Re: St. Lucie Unit 2
Docket No. 50-389
Order (EA-03-009) Interim RPVH Inspection Requirements
Revised Relaxation Requests 1 and 2 - Supplement 4

**ST. LUCIE UNIT 2 RELAXATION REQUEST NO. 1 REVISION 2
FROM US NRC ORDER EA-03-009**

**ST. LUCIE UNIT 2 RELAXATION REQUEST NO. 2 REVISION 1
FROM US NRC ORDER EA-03-009**

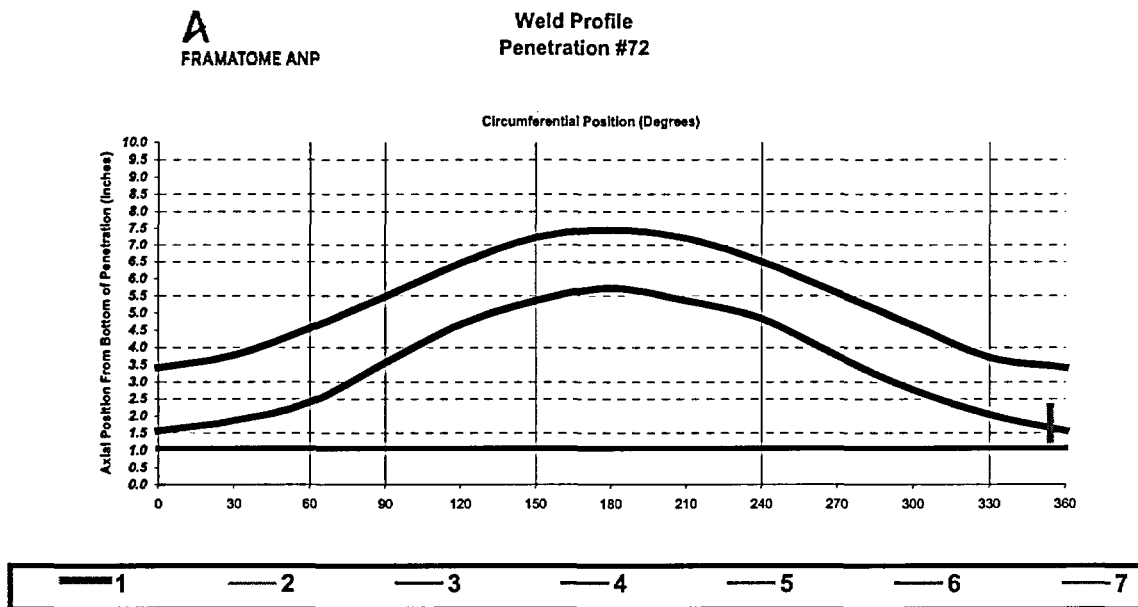
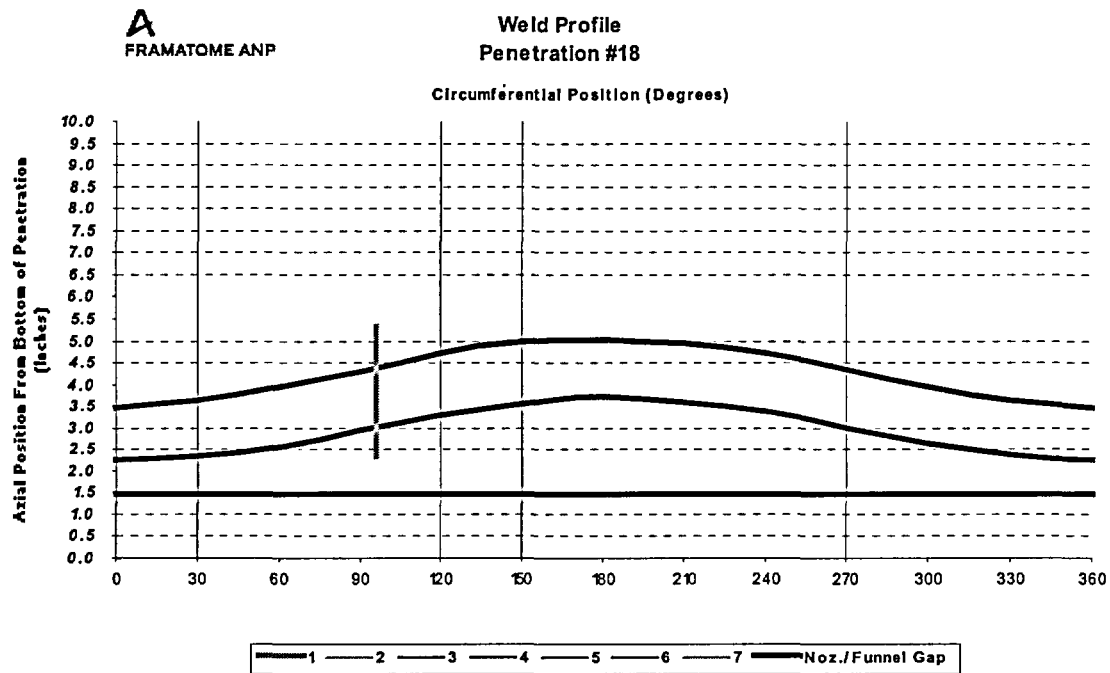
NRC Question 3: Provide the location of the flaw for Penetration Nos.18 and 72 relative to the weld and azimuthal angle around the nozzle.

FPL Response to Question 3: A single flaw was identified in Nozzle Nos. 18 and 72 at St. Lucie Unit 2. The details of each are provided in the table below. A graphical weld profile and flaw orientation is also provided. The 0° is identified as lowest downhill position of the weld.

Nozzle #	Flaw Location /Type	Azimuthal Location	Flaw Length	Flaw Depth	Distance Below Weld
18	OD Axial	96°	2.98"	0.26"	0.71"
72	OD Axial	354°	0.96"	0.28"	0.35"

Figure 1: Picture Showing Shroud Support Lug and Flashing Location

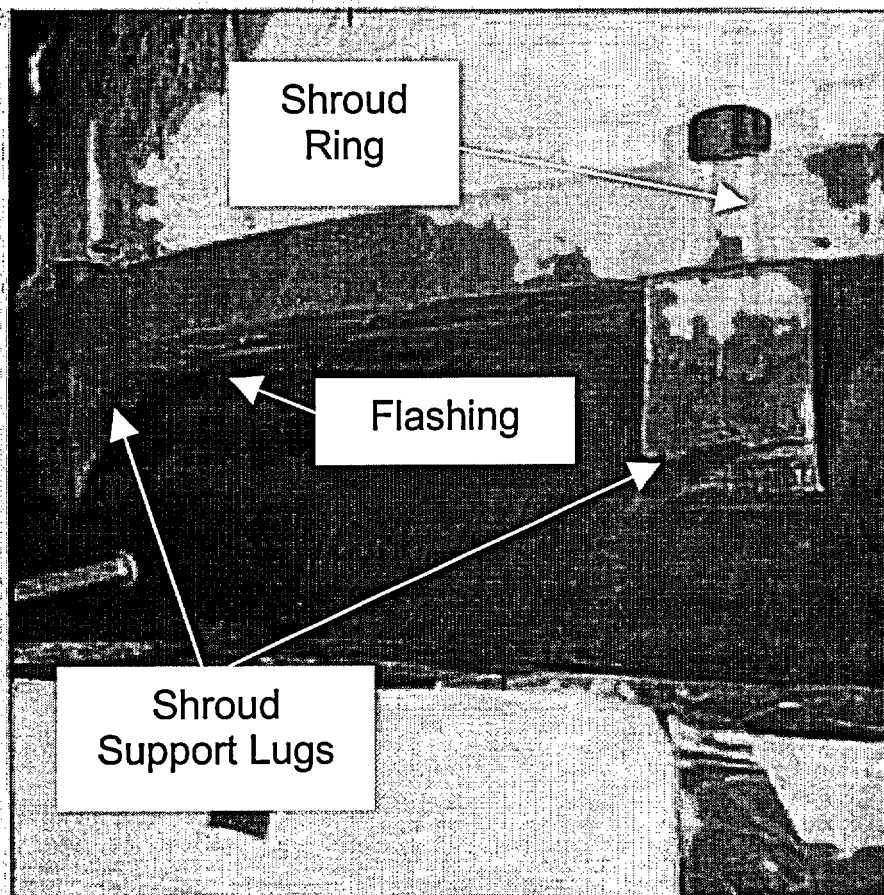
Relaxation is requested from part IV.C.(1)(a) of the Order to perform "bare metal visual examination of 100% of the RPV head surface (including 360° around each RPV head penetration nozzle)" at St. Lucie Unit 2. Specifically, FPL is unable to completely comply with this requirement due to inaccessibility to a small portion of the RPV head surface. The inaccessible areas are behind the twelve 6-inch wide shroud lugs and under the horizontal reflective metal insulation (RMI) support legs.

FPL has achieved substantial compliance with the 100% requirement by conducting a bare metal visual examination of the RPV head surface to the extent practical, excluding the inside of the 54 RPV stud holes. Specifically, the examination included a visual examination of 100% of the nozzle-to-top-of-head interface region (360°) of each RPV head penetration nozzle for evidence of leakage and an examination of the bare head surface for evidence of wastage or corrosive products.
